**ADDENDUM # 1**

<b>Project</b>	TA Blakelock High School Renovations	<b>Project No.</b>	2215-C
<b>Location</b>	1160 Rebecca Street, Oakville, ON	<b>Date of Issue</b>	2025 04 24
<b>Owner</b>	Halton District School Board	<b>File</b>	2215/7.1.3

This Addendum forms part of the Contract Documents and amends the original Drawings and Specifications, dated 2025 04 17, and all preceding Addenda, as noted below.

17 PARAPET SECTION DETAIL AT ELEVATOR 2  
A106 1:10

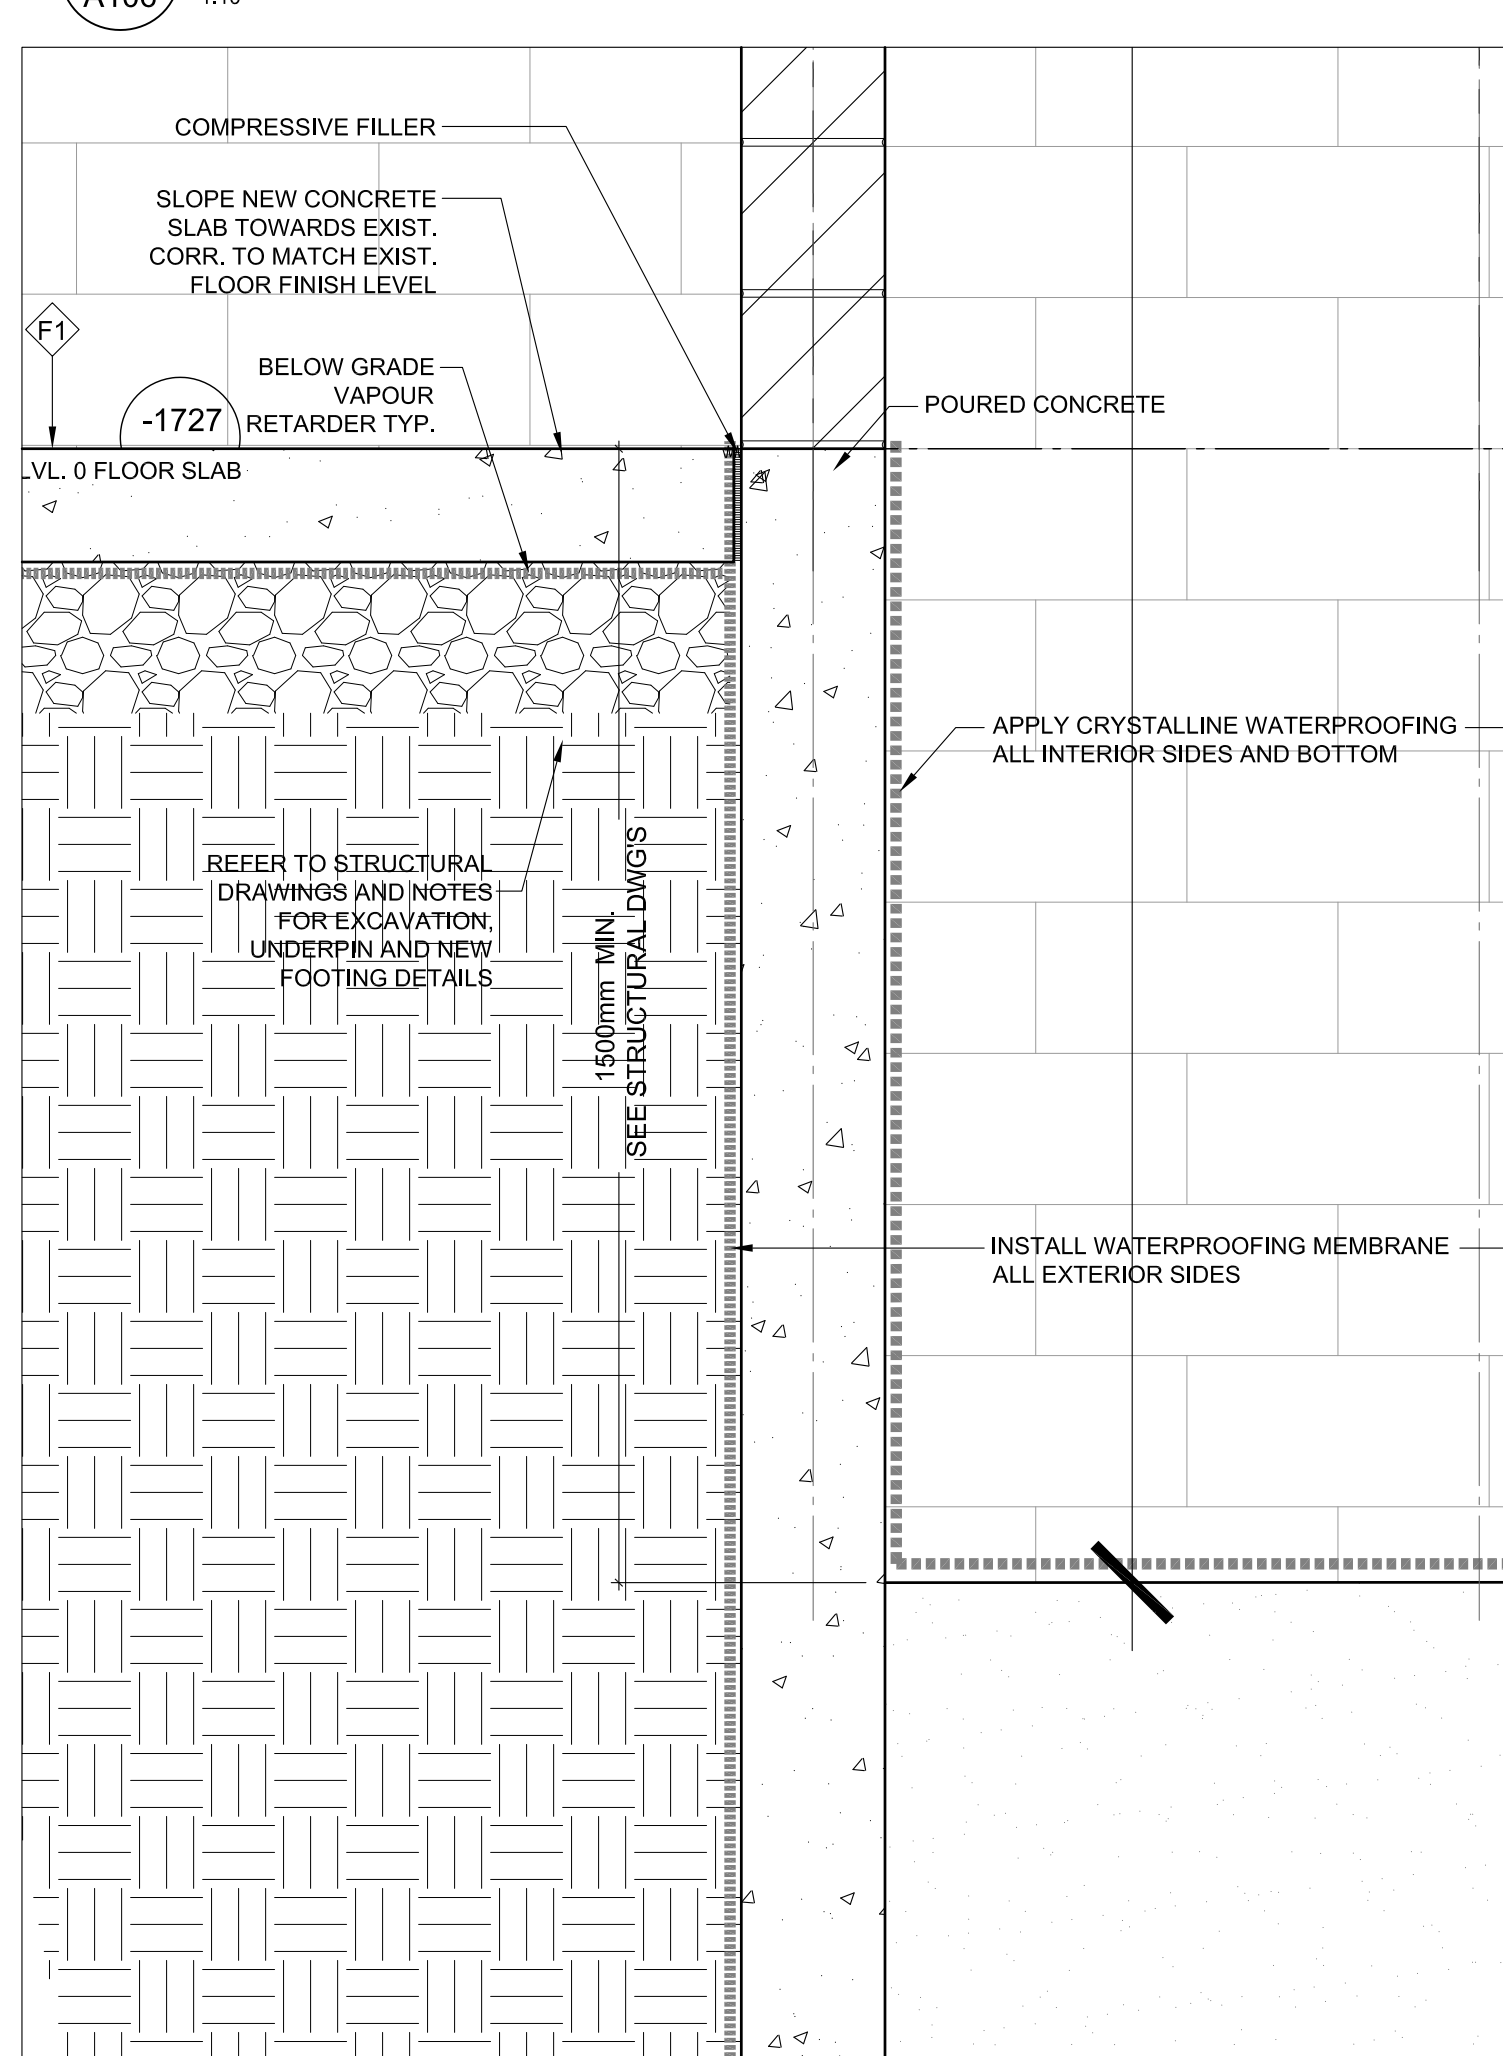
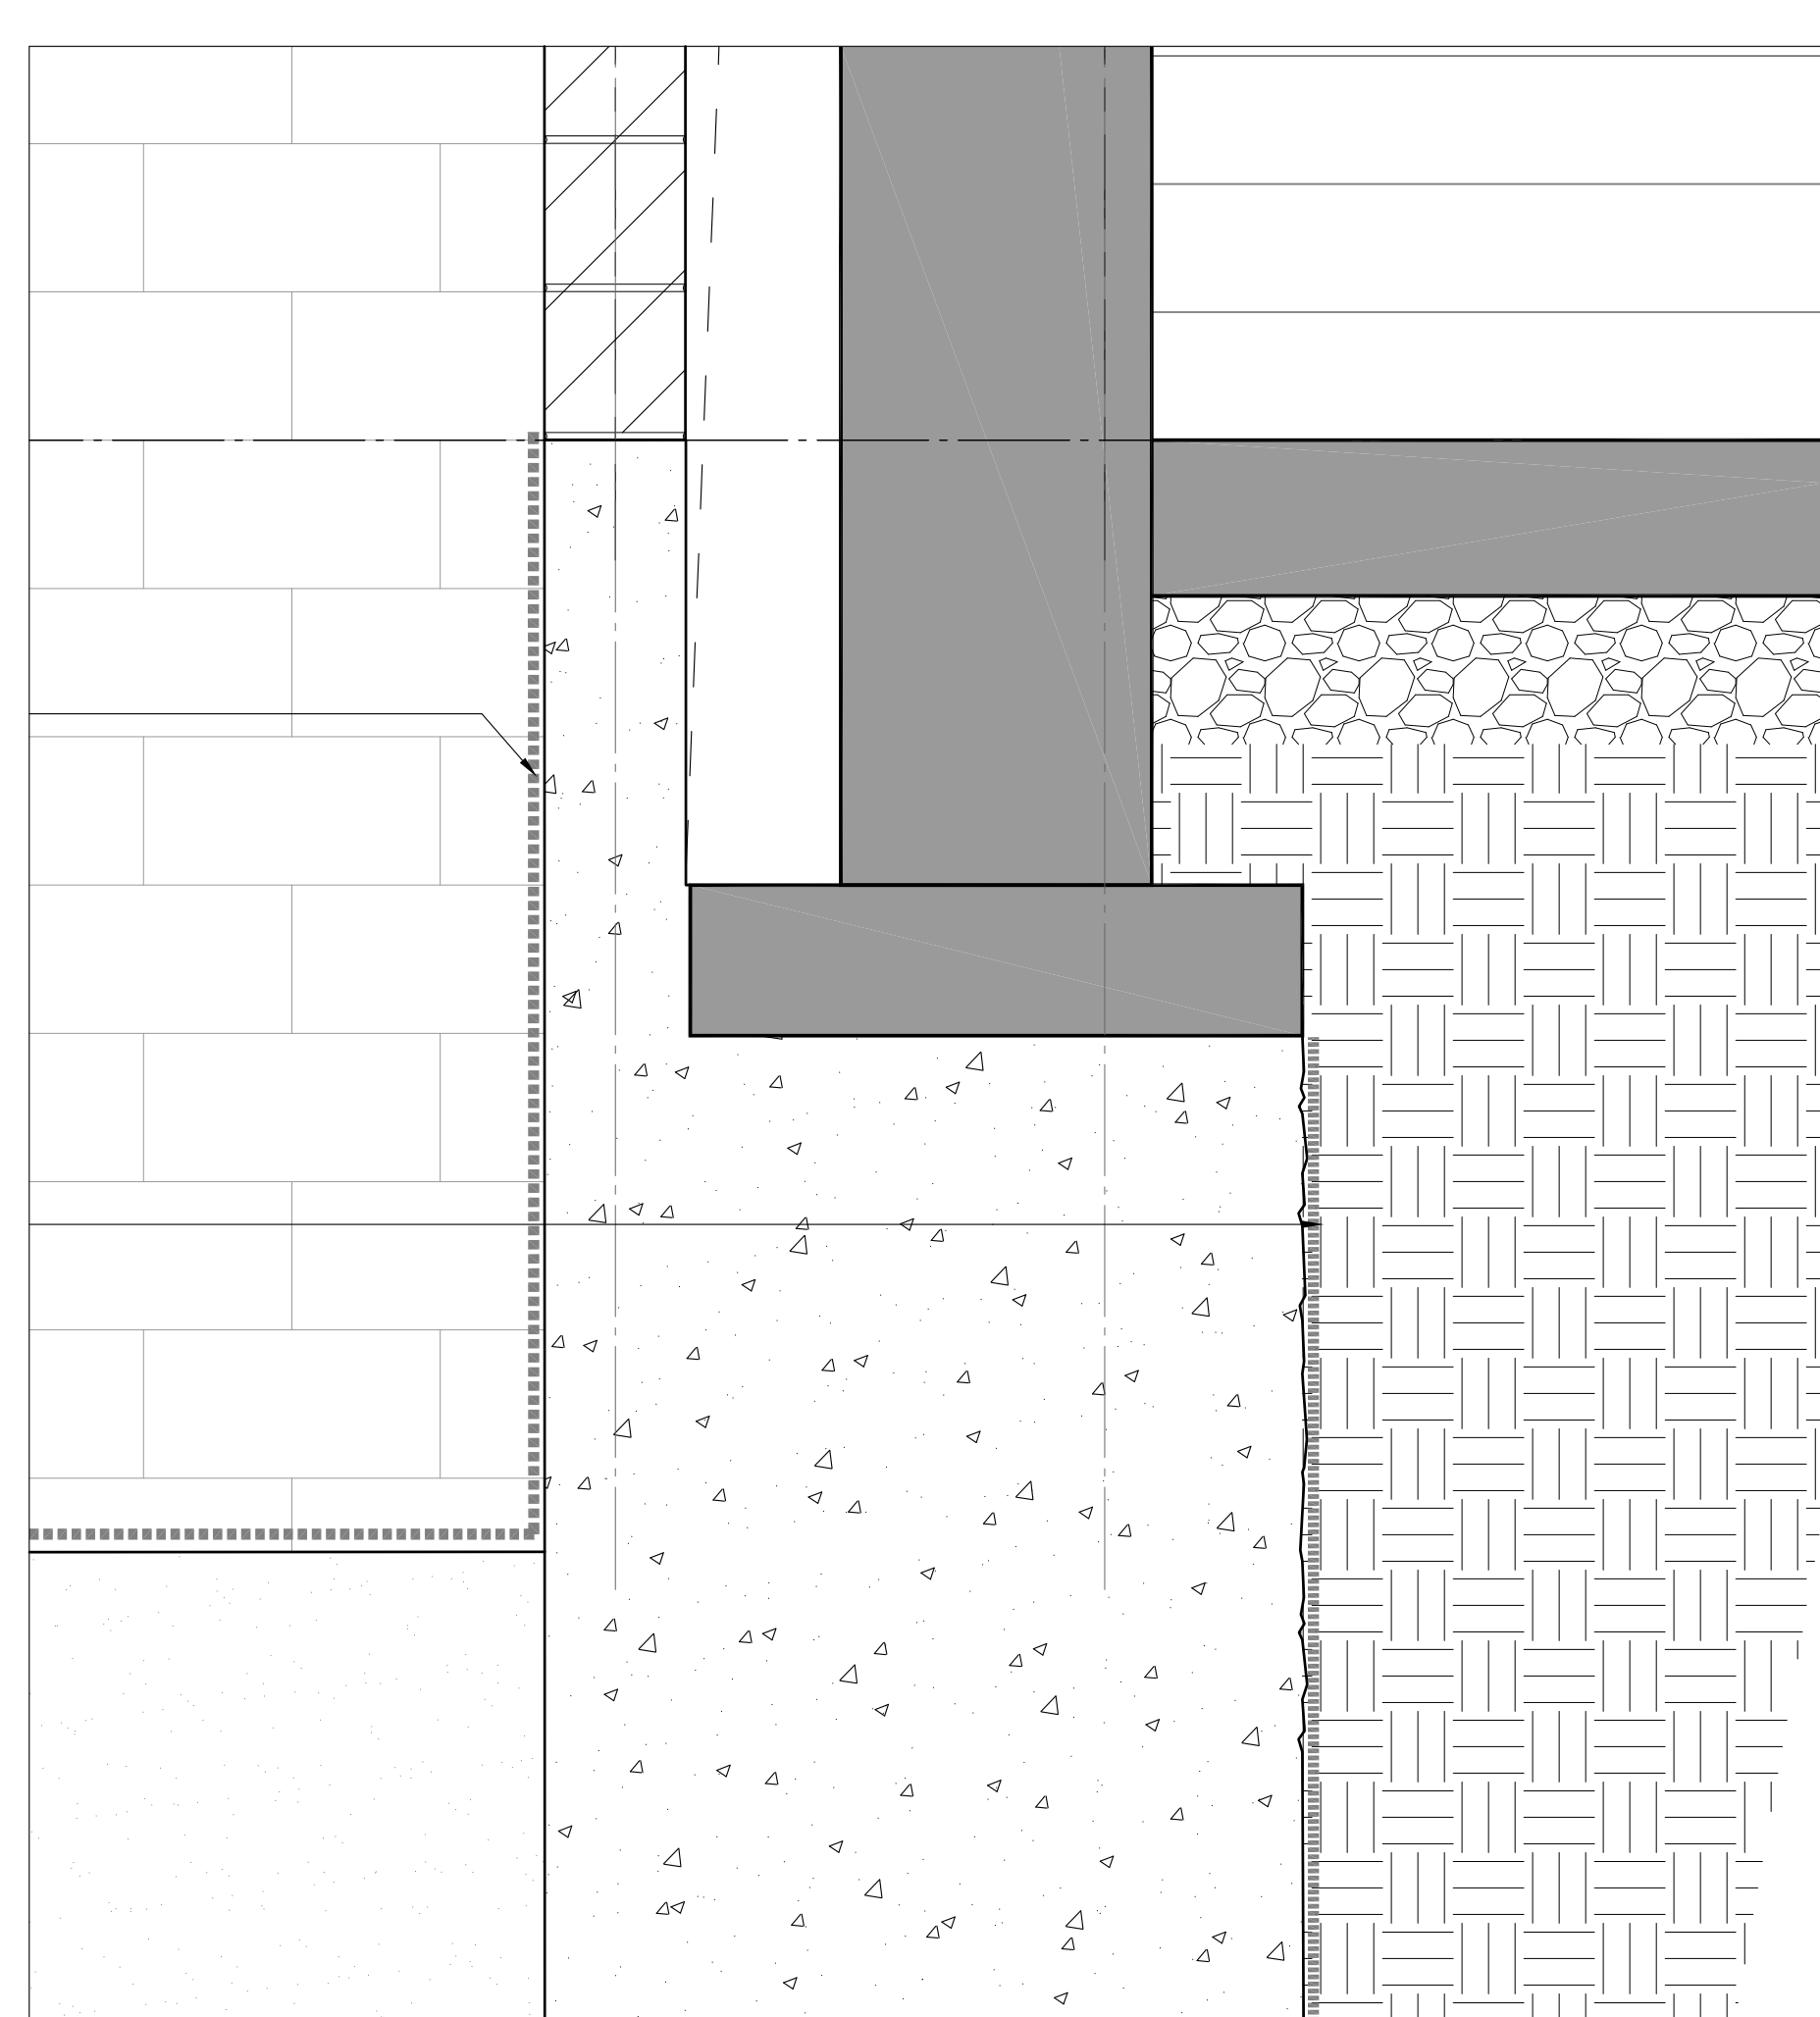
- .1 Replace Drawing with the attached Revision No. 2.
- .2 Drawing reissued to revise fire protection notes and added details 14-18.
